SAFETY RECALL RVXX0601 FEBRUARY 2006

Volvo Trucks North America has decided that a defect which relates to motor vehicle safety exists in certain Volvo VHD, VNL, and VNM model vehicles manufactured with a Volvo D12 Engine from November 2002 through January 2006. These vehicles may be subject to a safety issue in the event that an Exhaust Gas Recirculation ("EGR") Cooler Pipe becomes damaged or loose.

Arrows depict EGR Cooler Pipes

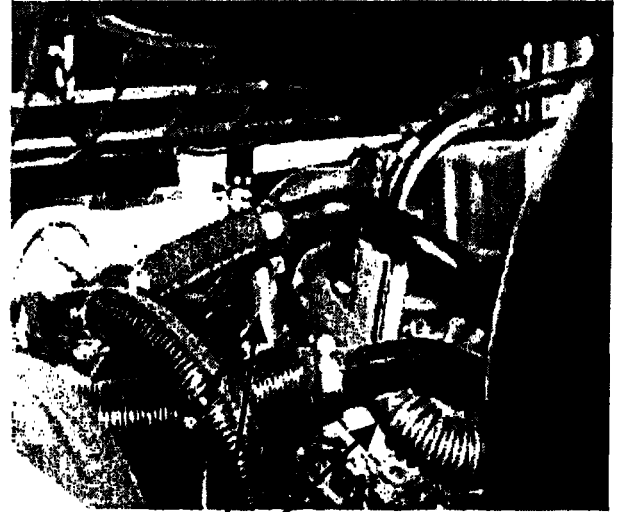
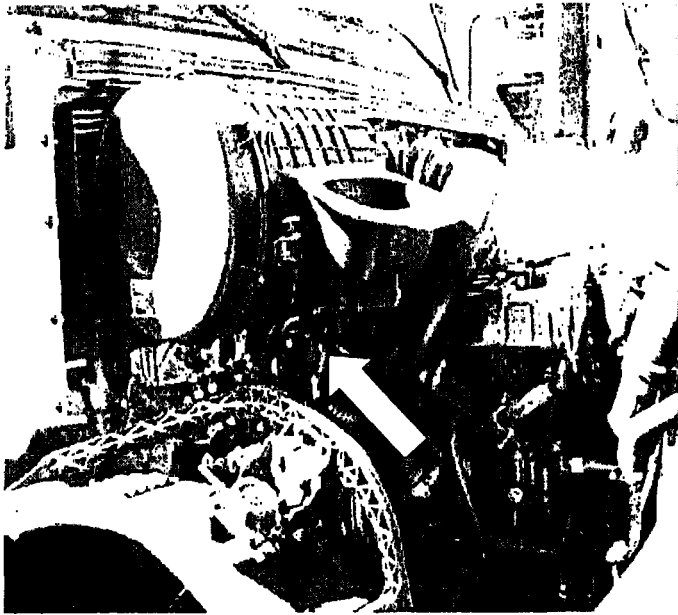
The EGR Cooler Pipes are located under the hood on the upper right side (passenger side) of the engine and can be seen by looking under the air cleaner at the rear of the engine. The following images/pictures show the EGR Cooler pipes and the inspection locations:

With the engine OFF **and the pipes cool,** inspect the area around the EGR cooler pipes for signs of cracks or separation of the pipe from the cooler. Sooting could indicate a loose clamp or a crack in an EGR cooler pipe.

If a pipe is cracked or leaking, contact your nearest Volvo Parts and Service Center for repair.

If a **pipe is separated, DO NOT OPERATE THE VEHICLE!** Contact the Volvo Action Service Support Center at 1-877-800-4945 for further instructions.
